South Staffordshire Water PLC Representations on Ofwat's draft determination of our business plan for 2025 to 2030

We have submitted the following overviews of our key arguments and representations to Ofwat’s draft determination of our business plan for the five years from 2025 to 2030.

1.3.2 Assumption of symmetrical distributions and no truncation

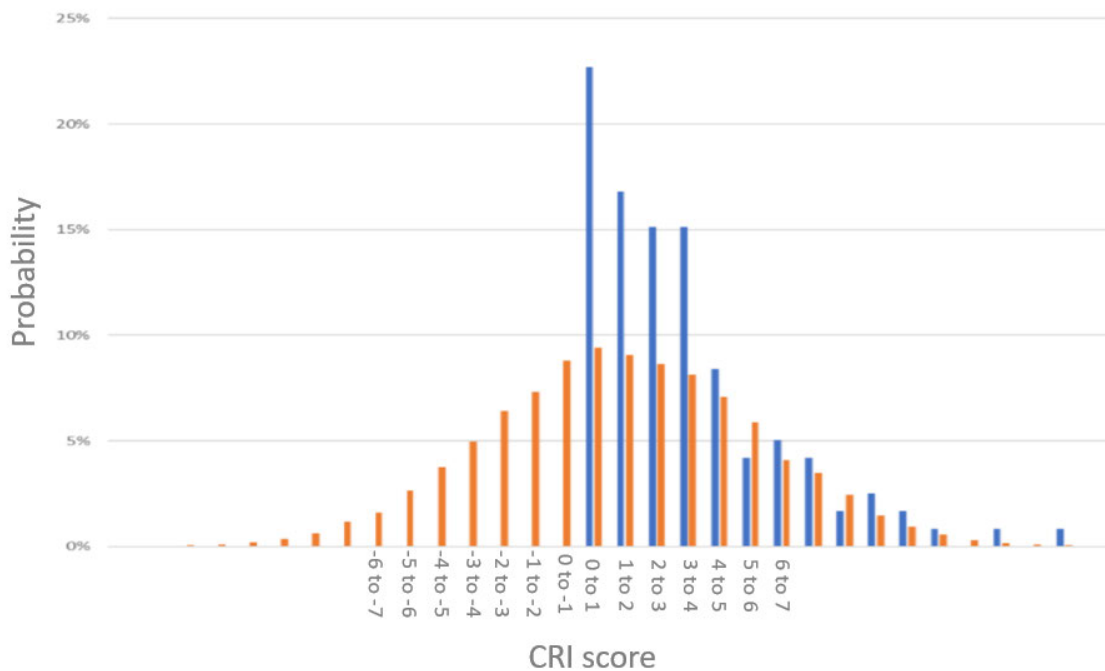
Our understanding of Ofwat's Monte Carlo modelling approach is that all PCs are assumed to follow a normal distribution. This means the assumption is that all risk distributions are perfectly symmetrical, as a normal distribution does not allow skew.

An example of the inappropriateness of Ofwat's approach is shown below, using a histogram of CRI data. The blue bars represent actual data, and the orange bars represent Ofwat's model using the normal distribution. First, it is not possible for CRI to be a negative value, yet with no truncation Ofwat's model allows this to occur. In addition, the choice of distribution does not reflect the correct P50 level, which is not at zero.

1.3.3.1 Water quality contacts¹

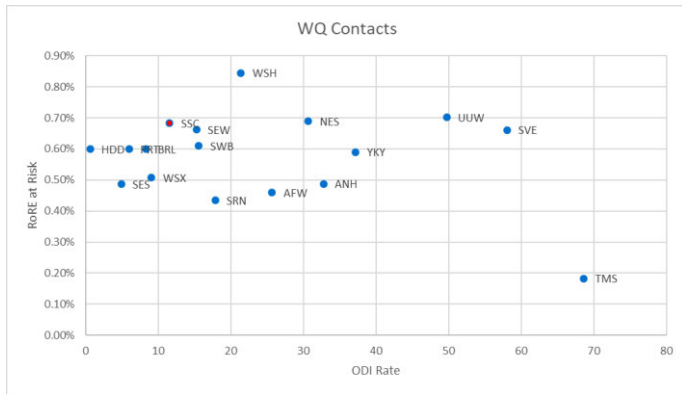
For water quality contacts, we have the second highest return on regulated equity (RORE) at risk after the re-normalisation step.

It should be noted that this ODI rate in our draft determination is more than ten times higher than at PR19. At PR19, a single contact was worth £625; in our PR24 draft determination, it is now more than £6,600. This is a level far in excess of a reasonable compensatory value.

The resolution for this situation is, first, to remove the step in the ODI rate setting approach which re-normalises ODI rates. This will remove some of the very large ODI rates that are disproportionate for us compared with the rest of the sector. And, second, to make specific interventions as we list in section 1.4 to resolve specific PC risks.

1.3.3.2 CRI

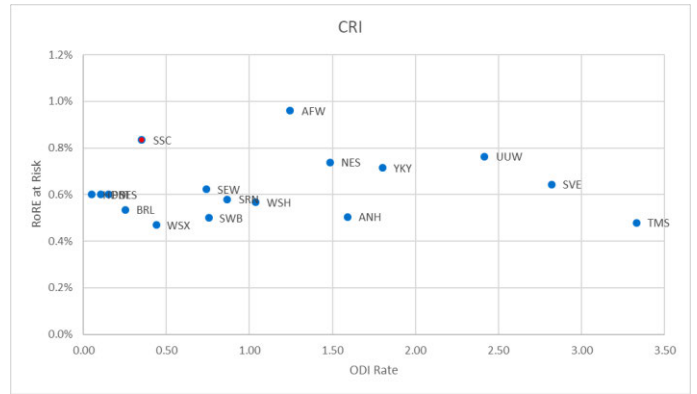
On CRI, we also have the second highest RORE at risk. The ODI rate here is 30% higher than at PR19.

1.3.3.3 Water supply interruptions

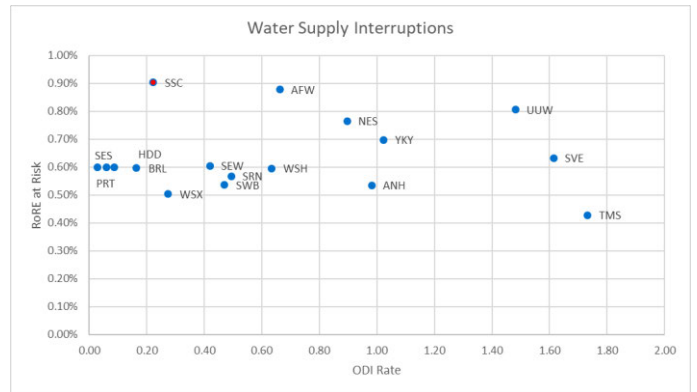
On supply interruptions, we have the highest RORE at risk.

1.3.3.4 Leakage

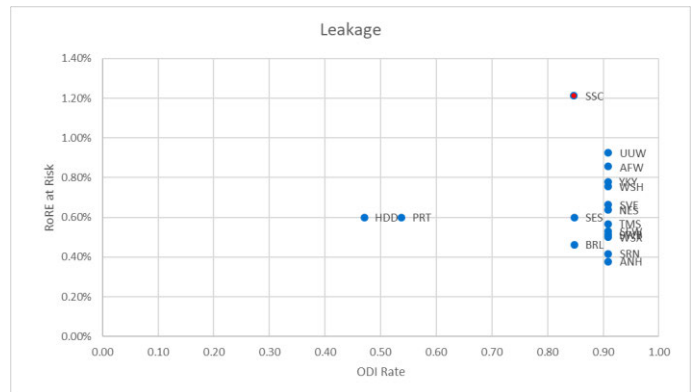
We are highest RORE at risk on leakage. ODI rates are more than three times higher than at PR19.

1.3.3.5 Business demand

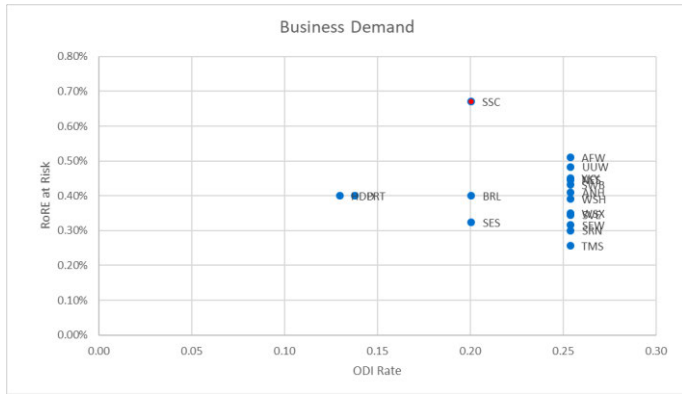
We are highest RORE at risk on business demand.

1.3.3.6 Mains repairs

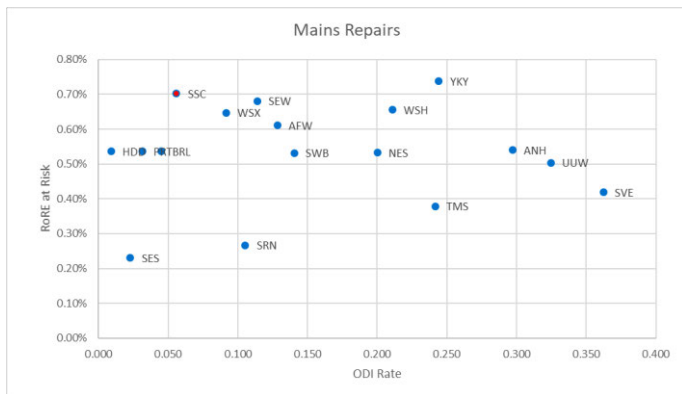
We are second highest for RORE at risk on mains repairs.

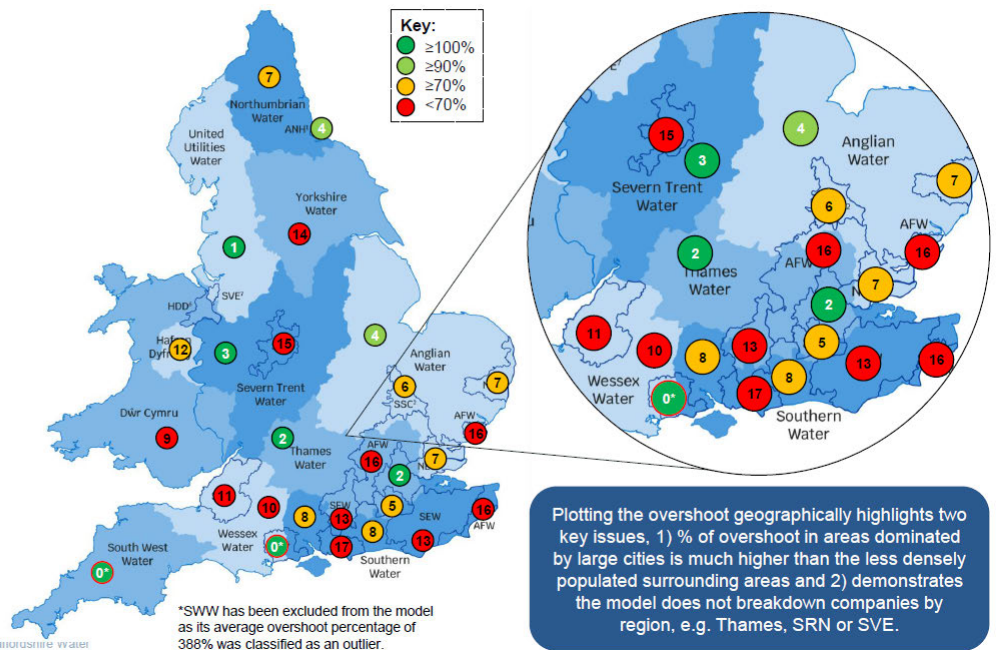
It is not reasonable that the model explains 100% of the PCC uplift for Severn Trent, but only 51% of the uplift for us, given that we operate in the same area of the country. This demonstrates that the granularity of data and the geography of the region matters. It does appear that much larger companies, with both large cities and surrounding rural areas, are better served by the model than smaller companies that border these larger ones.

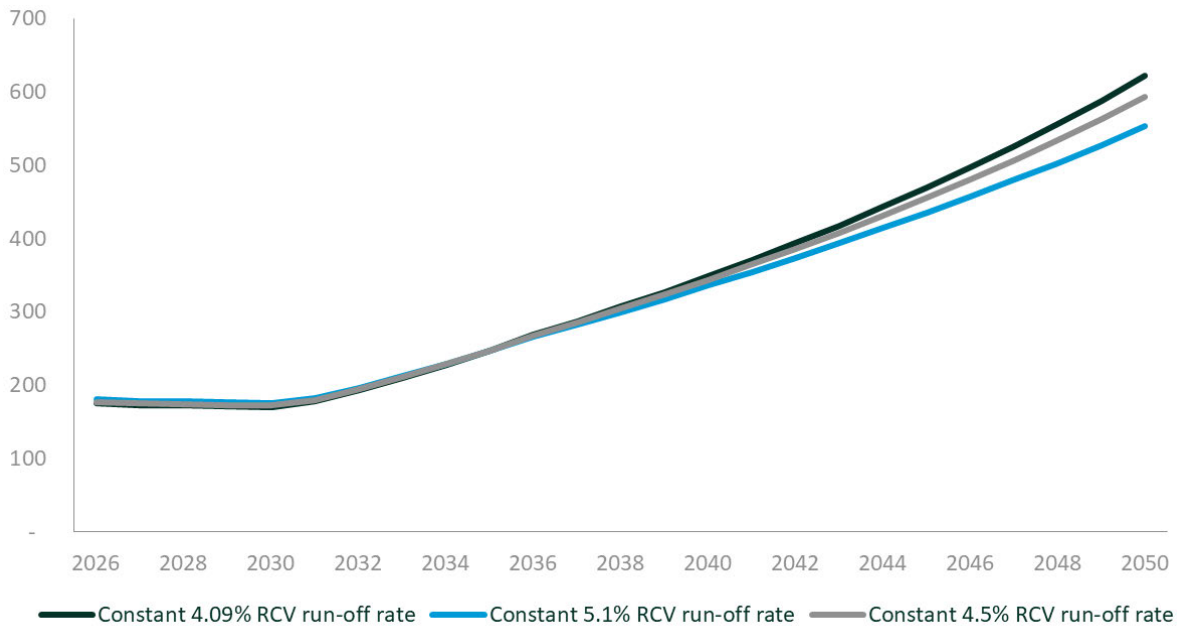
Executive pay policy

designed to enable us to attract, retain and motivate high-calibre Executive Directors across the business, while making sure we always comply with our legal and regulatory requirements.

So, we are asking Ofwat to unwind its proposed RCV run-off reduction and allow a rate of 4.5%, as set out in our business plan.
